Item ID: D212-664-101 Accept *N900040100* Setup Start *NS1*
 Revision ID: Stop *NS2*
 Item Name: Crosstube Fwd High
 Start Date: 9/05/12 Start Qty: 1.00 *1* Cust Item ID:
 Required Date: 9/05/12 Req'd Qty: 1.00 *1* Customer:
 Reference:

DRAWING NO. D212-664-141	TITLE XTUBE ASSY (205/212/412 HI FWD)	REV. D	DART AEROSPACE LTD ENGINEERING ORDER		D.E.O. NO. D212-664-141-D-1	SHEET NO. SHEET 1 OF 2	SCALE NTS
DRAWN	CHECKED	MFG. APPR.	APPROVED	DE APPR.			
DATE 11.04.07	DATE 11.04.11	DATE 11.04.12	DATE 11/04/12	DATE 11.04.12

PURPOSE:

ADD AN INSPECTION WINDOW TO UNDERSIDE OF CROSSTUBE.

**D212-664-141/141B
ASSEMBLY DETAIL**

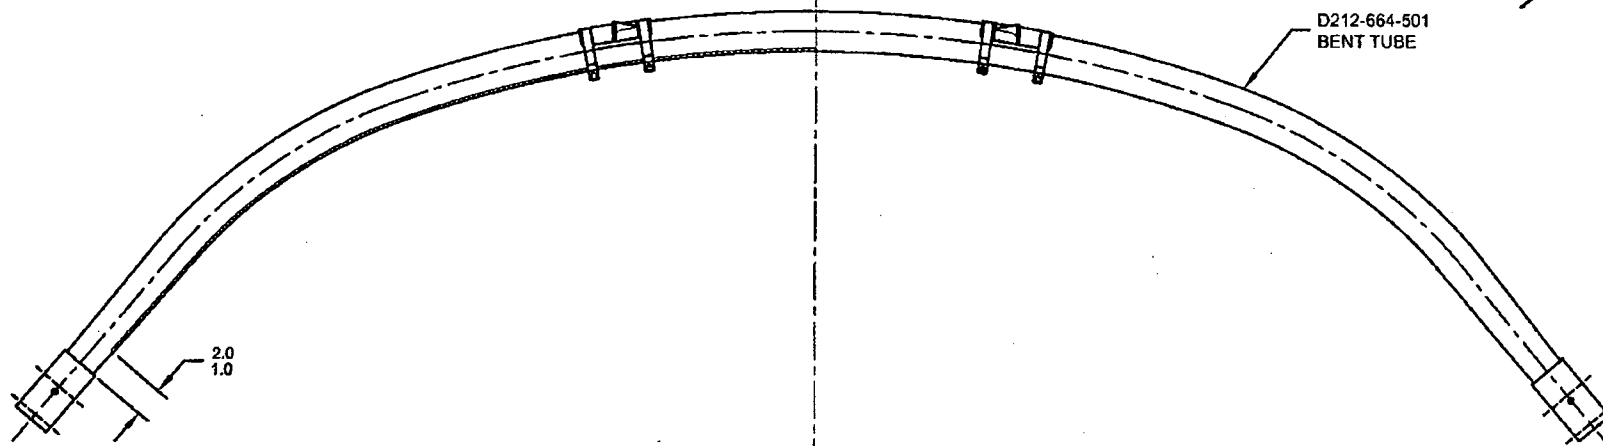
NOTES 2 OF SHEET 1 IS AMENDED AS FOLLOWS:

MASK AREA PRIOR TO PAINTING,
REMOVE MASKING AFTER PAINT
AND APPLY CLEAR COAT

- 2) FINISH: CHEMICAL CONVERSION COAT PER DART QSI 005 4.1
PRIME INSIDE AND OUTSIDE PER DART QSI 005 4.2
MASK UNDERSIDE OF CROSSTUBE AS SHOWN (HATCHED AREA) AND
PAINT OUTSIDE PER DART QSI 005 4.2
REMOVE MASKING AND APPLY CLEAR COAT
